Responsible: Dieter Rutz
Date: 20.02.2014

EKI 9350.1 Rectifying fault «ER03»

Rectification

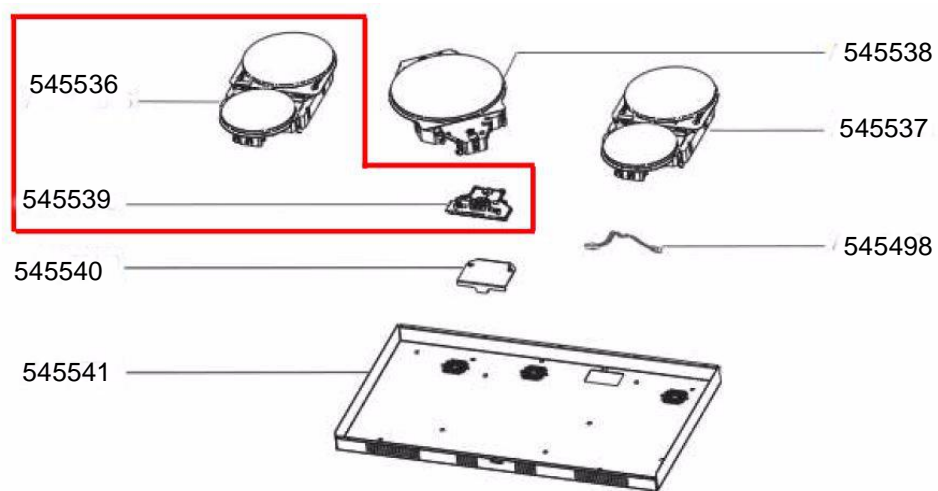
An endurance test carried out by the quality Department recently showed a component weakness in model EKI 9350.1. This may give rise to error message ER03.

The Basic 2 module 160P/160IPS and the touch control need to be replaced.
